Subject: **Project Consultation - Approved Pier and Grade Beams, Setbacks and Drainage FOR NEW REAR YARD DECK EXTENSION and ADDITIONS AT 1151 GLENEAGLES TERRACE COSTA MESA, CALIFORNIA**

Application No. ZA-09-37- A1

HOME REMODEL AT
1151 GLENEAGLES TERRACE
COSTA MESA, CA

Application Number: ZA-09-37 A1

BLUFF CREST DIMENSIONS AS DOCUMENTED IN APPROVED PLANS

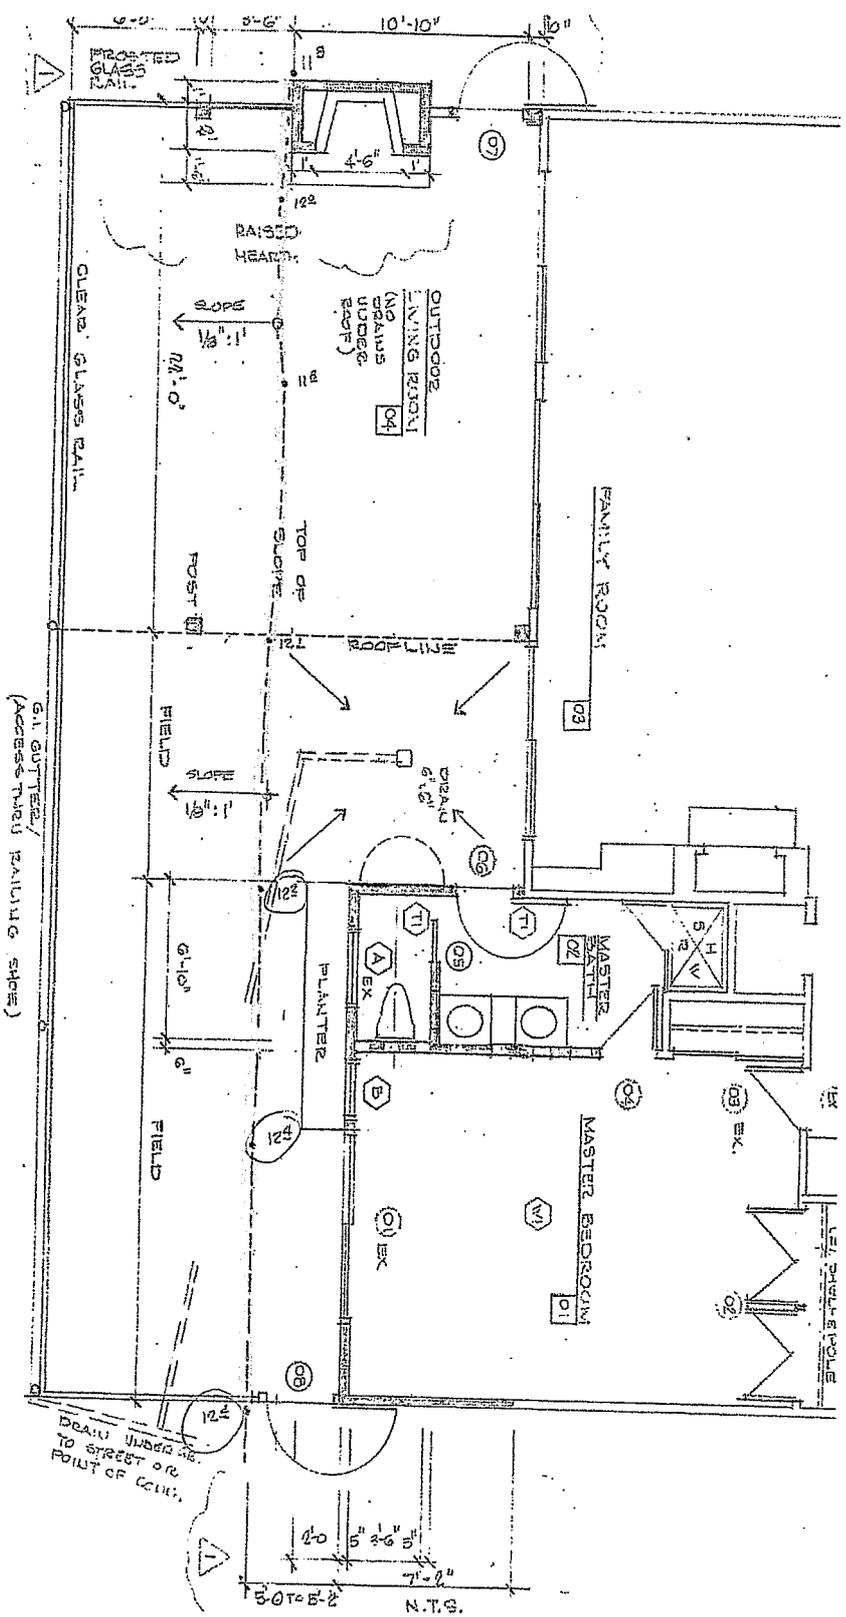
- BLUFF CREST IS RELATIVELY CONSTANT IN DEPTH ACROSS PROPERTY
- BLUFF CREST IS DEFINED IN PLANS REVIEWED AND APPROVED BY THE CITY

FOUNDATION FOR BEDROOM/BATHROOM EXTENSION

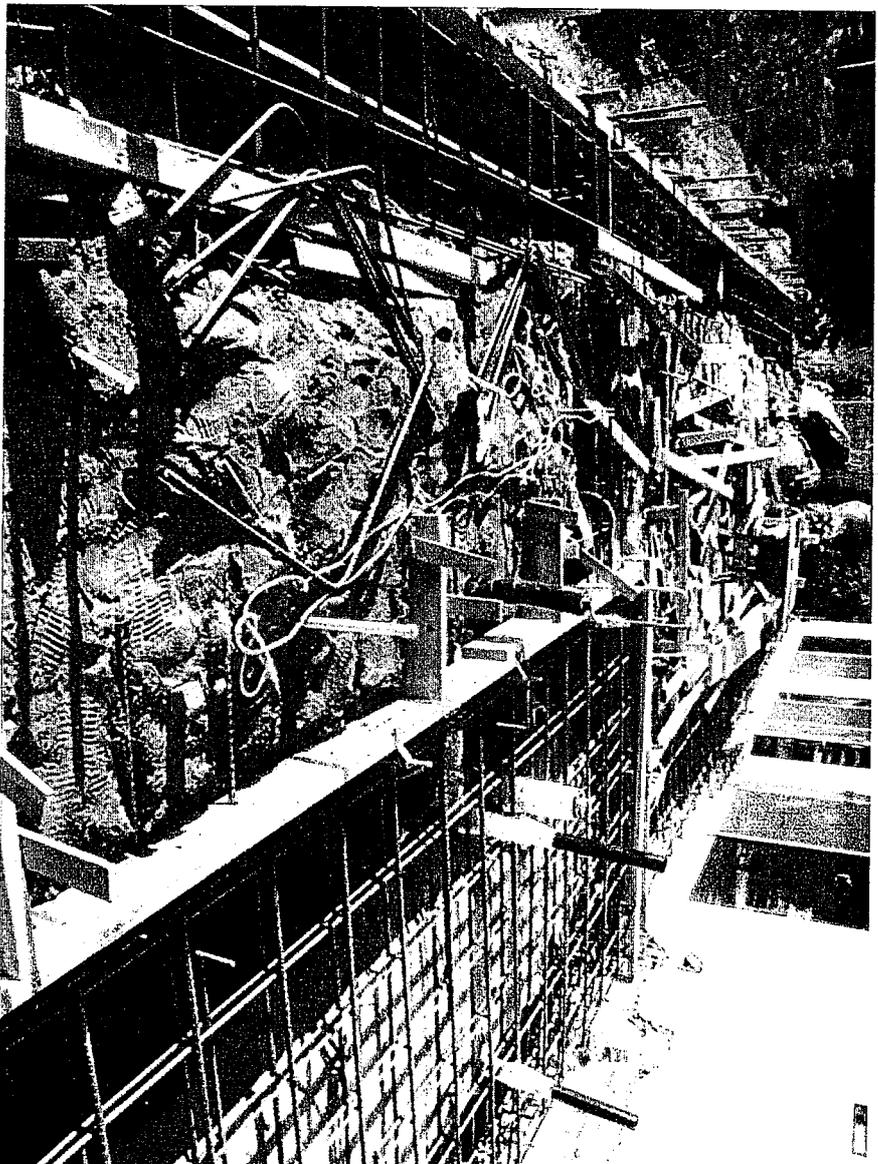
- **GRADE BEAM IS LOCATED JUST BELOW FORMER BLUFF CREST**
- **GEOLOGIST REPORT STATES “..NEW CONSTRUCTION WILL NOT IMPACT THE GEOLOGIC STABILITY/SAFETY OF THE SUBJECT OR SURROUNDING SITES.”**

PROPOSED SETBACK FOR MASTER BEDROOM/BATHROOM EXPANSION IS 4 FEET 3 INCHES FROM BLUFF CREST

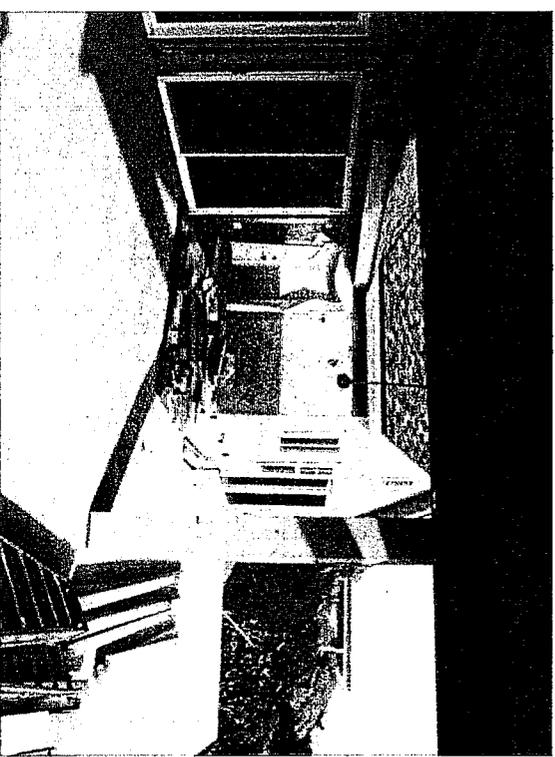
- **APPROVED SETBACK FROM BLUFF CREST IS 5 FEET**
- **ROOM EXTENSION AND FOUNDATION WAS INSPECTED BY CITY PERSONNEL DURING CONSTRUCTION**
 - **AT LEAST THREE INSPECTIONS CONDUCTED BY A TEAM OF CODE ENFORCEMENT, PLANNING, AND BUILDING INSPECTION PERSONNEL**
 - **FOUNDATION WAS INSPECTED PRIOR TO CONCRETE POUR**
 - **PLUMBING MODIFICATIONS WERE INSPECTED PRIOR TO CONCRETE POUR**
 - **ROOF SHEATHING AND HEIGHT WAS INSPECTED AND APPROVED IN FEBRUARY TO AUTHORIZE INSTALLATION OF SHINGLES**

- **WE ARE REQUESTING APPROVAL OF REDUCED BLUFF CREST SETBACK FOR MASTER BEDROOM/BATHROOM EXTENSION**
 - **ENCROACHMENT WAS INADVERTENT BY OWNER AND CONTRACTOR**
 - **WENT UNNOTICED DURING SEVERAL INSPECTIONS BY CITY PERSONNEL**
 - **CODE ENFORCEMENT, CHIEF INSPECTOR, AND PLANNING**
 - **ACTUAL ENCROACHMENT WAS IDENTIFIED AND DOCUMENTED BY PROPERTY OWNERS**
 - **INTERIORS OF BEDROOM AND BATHROOM ARE READY FOR MECHANICAL AND ELECTRICAL INSPECTIONS**
- **WE ARE REQUESTING THAT MASTER BEDROOM/BATHROOM ROOF HEIGHT EXCEEDANCE BE APPROVED**
 - **ROOF WAS CONSTRUCTED TO MATCH EXISTING HOUSE PITCH**
 - **EXTENSION APPEARANCE IS CONSISTENT WITH HOUSE STRUCTURE**
 - **ROOF HAS BEEN INSPECTED AND FINISHED**

ROOF HEIGHT IS 13 FEET 6 INCHES

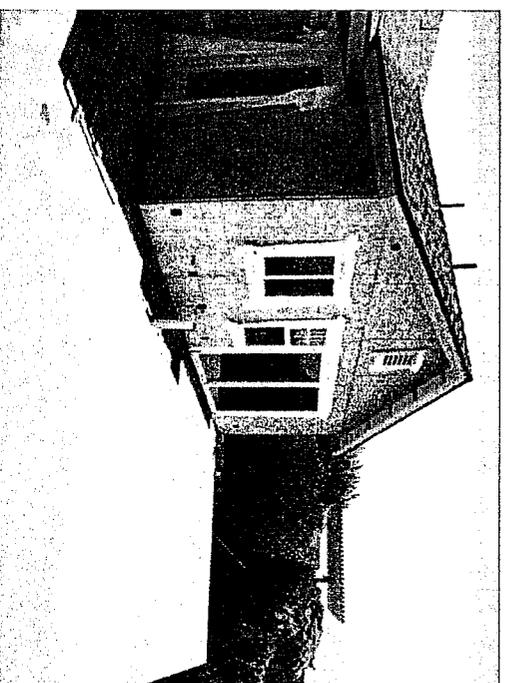
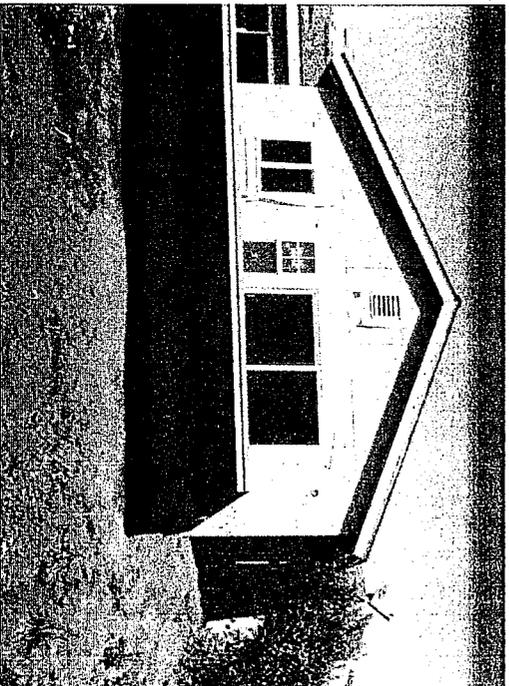
- APPROVED ROOF HEIGHT IS 12 FEET 6 INCHES
- MASTER BEDROOM/BATHROOM ROOF MATCHES PITCH OF HOUSE ROOF
 - ROOF WAS INSPECTED BY CITY PRIOR TO FINISHING
- PEAK OF MASTER BEDROOM/BATHROOM ROOF IS LOWER THAN HOUSE ROOF
